CITY OF SOUTHGATE PLANNING COMMISSION AGENDA

Special Condition and Site Plan Review

ACTION REQUESTED: Special Condition/Site Plan Review

DUMPSTER BLOCK PANEL
DETAIL

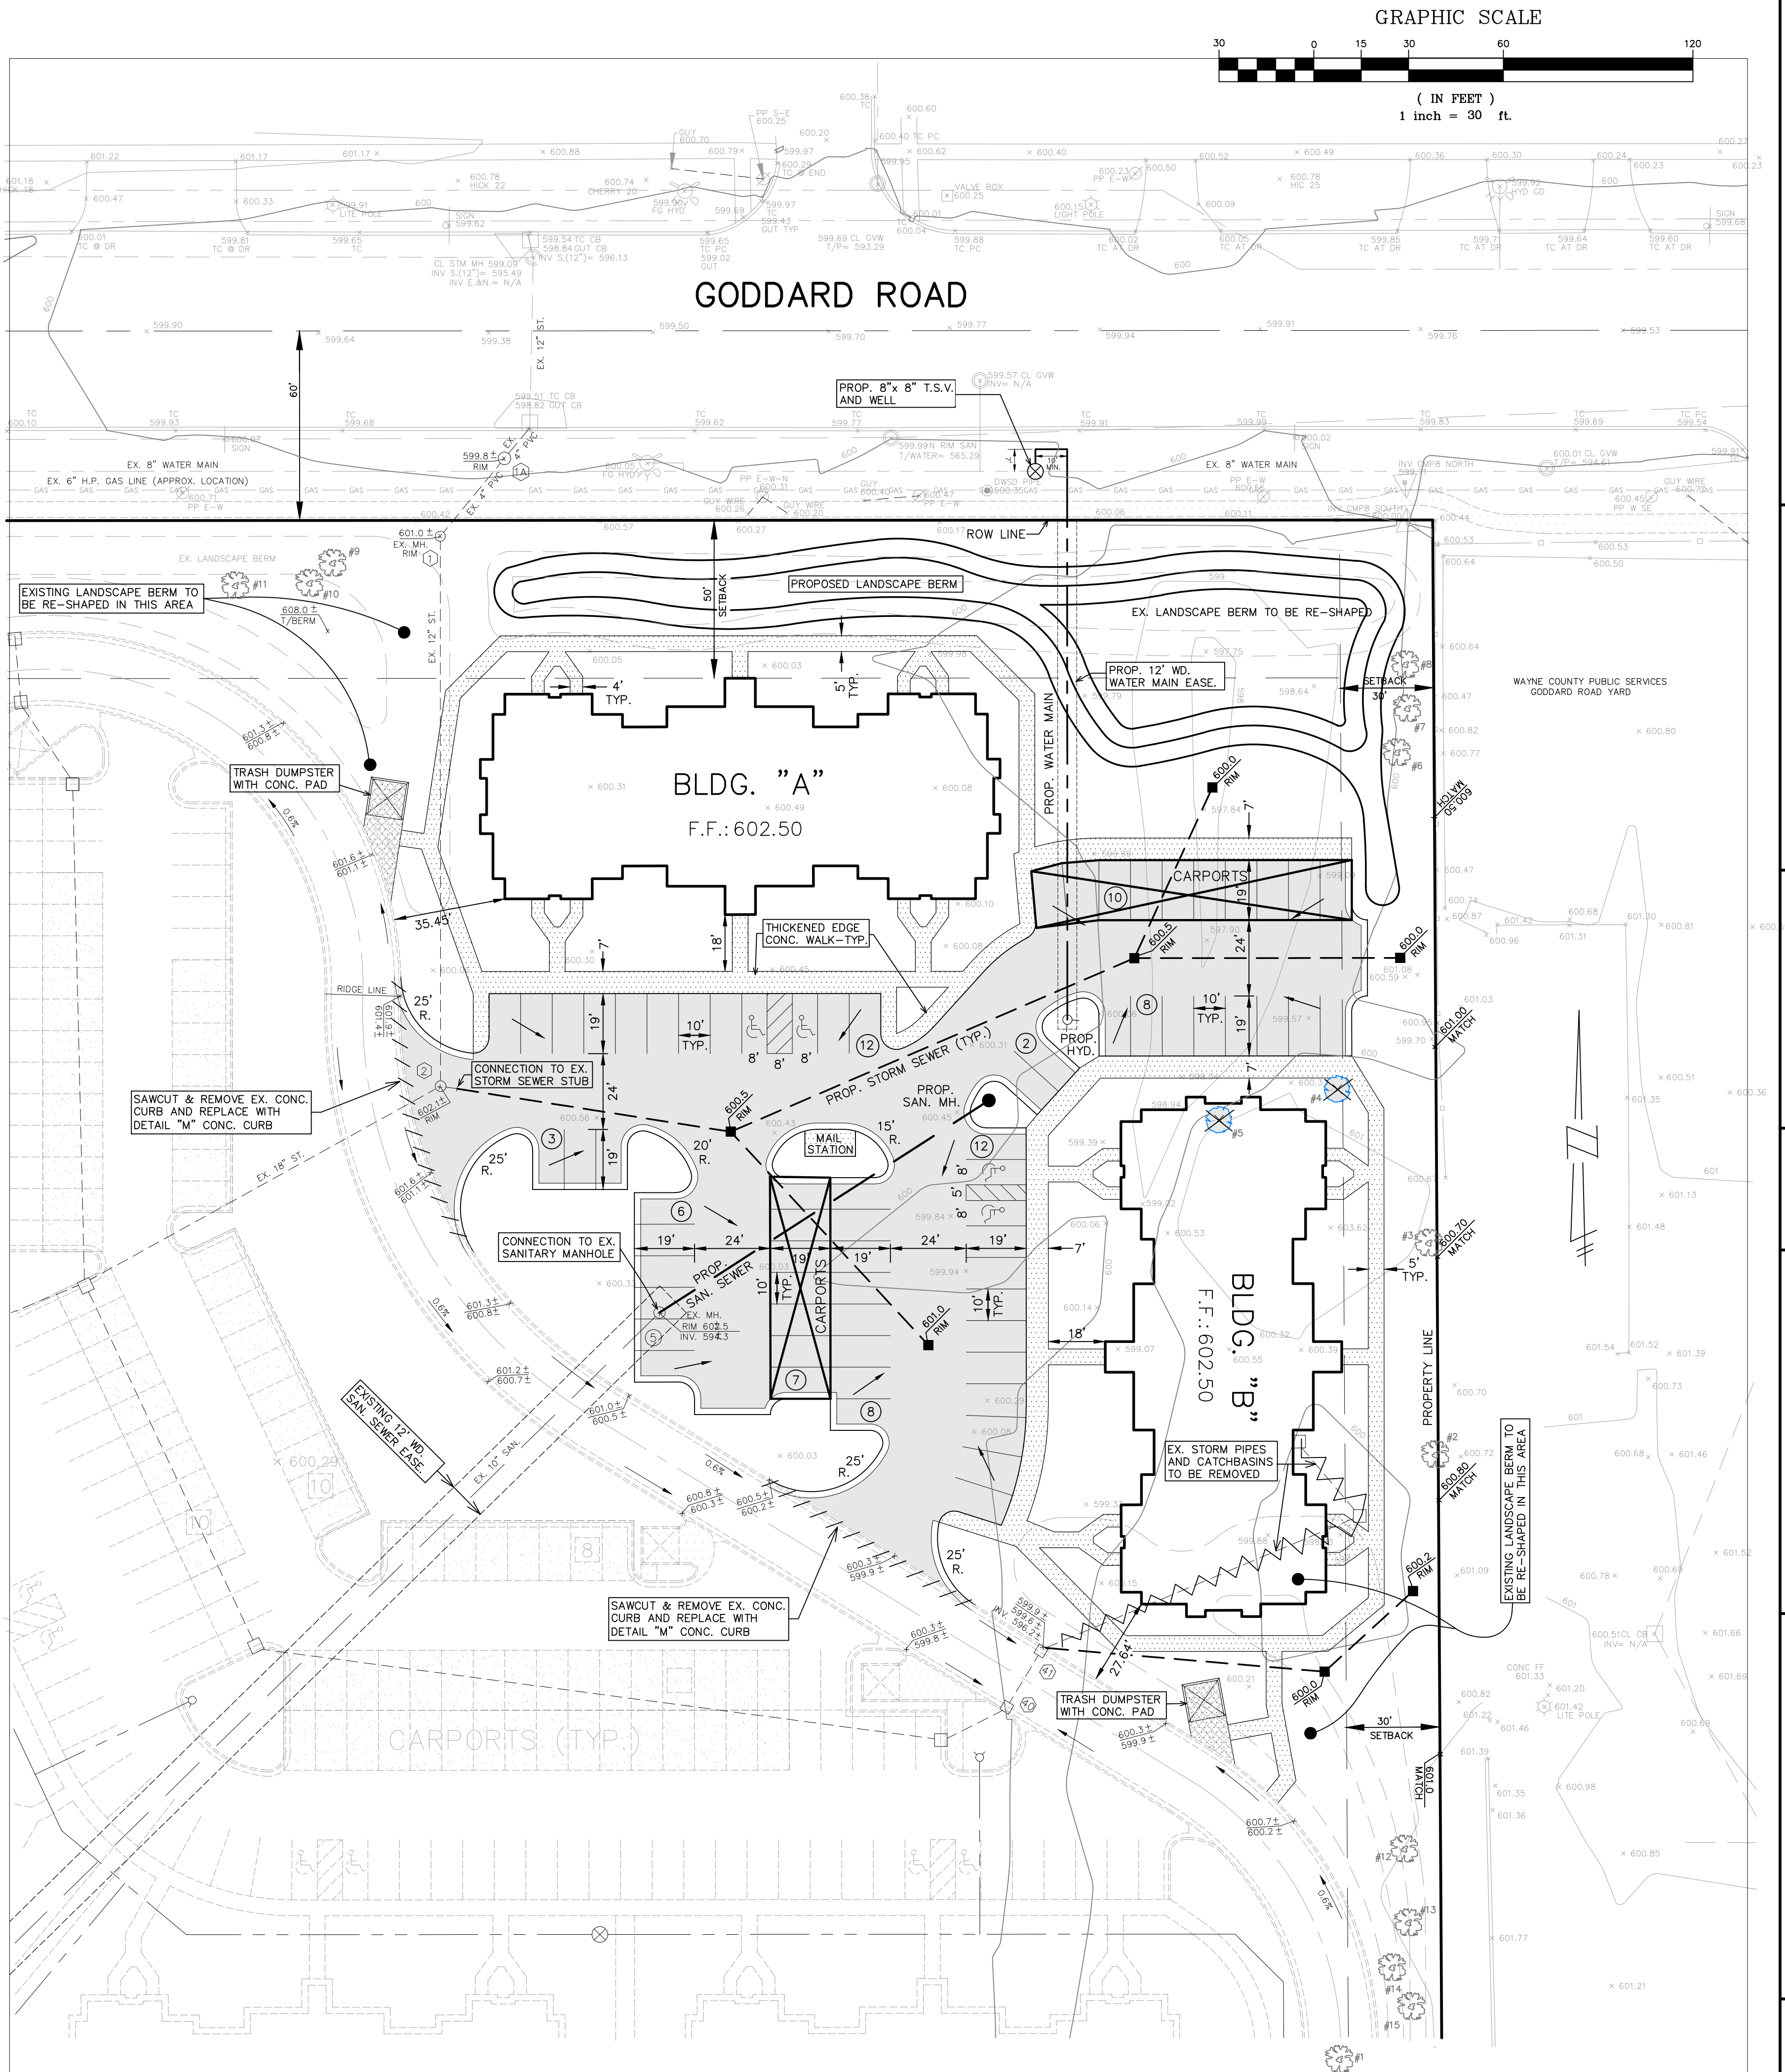
5. Approval of site access and circulation by Fire Department. —————→
6. Approval of site access and circulation by City Engineer. —————→
7. Provide elevations of dumpster enclosures. Added to sheet 3

Waste/Dumpster Enclosure: Two (2) new dumpster enclosures on concrete pads are proposed on the northwest and southern areas of the expansion site. Elevations of the dumpster enclosures have been provided on sheet 3 of revised plans.
